Technical product information

Transaction No.: **2033456/1**

1.6l CR Injectors_Electrical fault

Release date: 28-Mar-2013

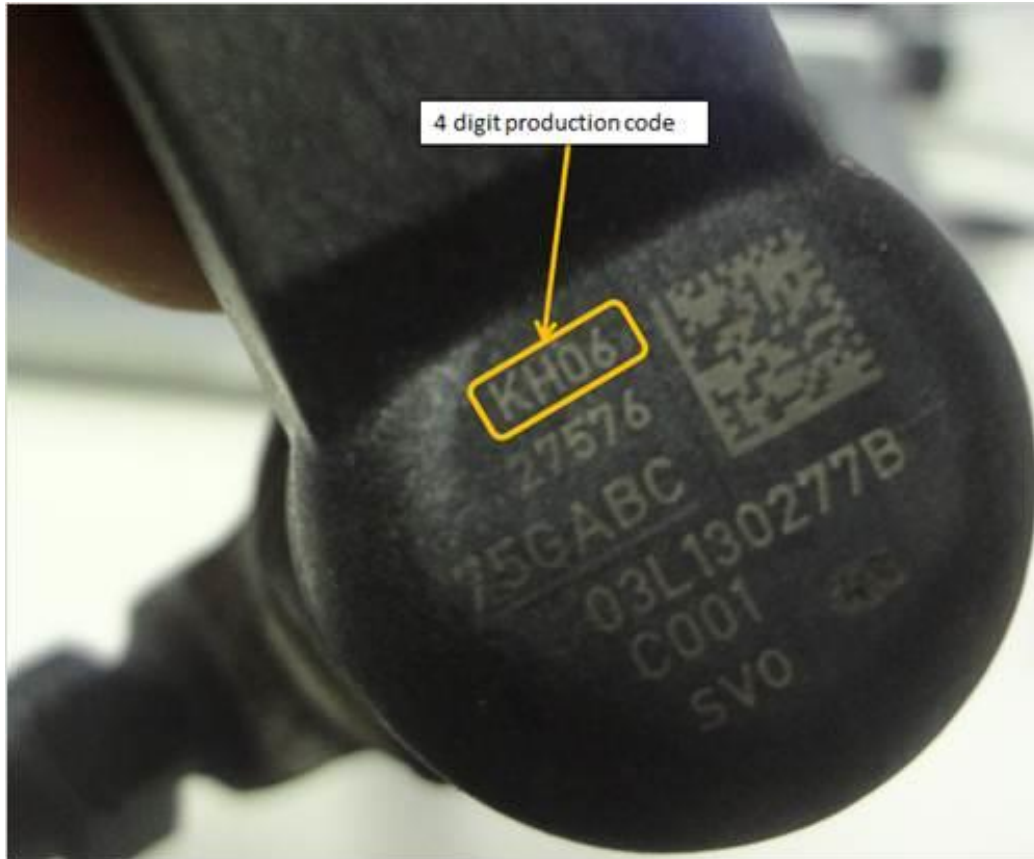
Check electrical connection of injector for loose contact & contact corrosion, if found then repair accordingly.

In the event of above faults observed in diagnostic log, Take pictures of faulty injector (which is recognised as an electrical fault in diagnostic log) as shown in below picture:

Defective injector must be replaced by improved injector as per following guidelines:

All injectors which are produced after 15th Jun.2012 are improved & should be used for replacement of defective injectors.

Please read four letter code on Injector e.g. KH06 (06th Aug 2011)
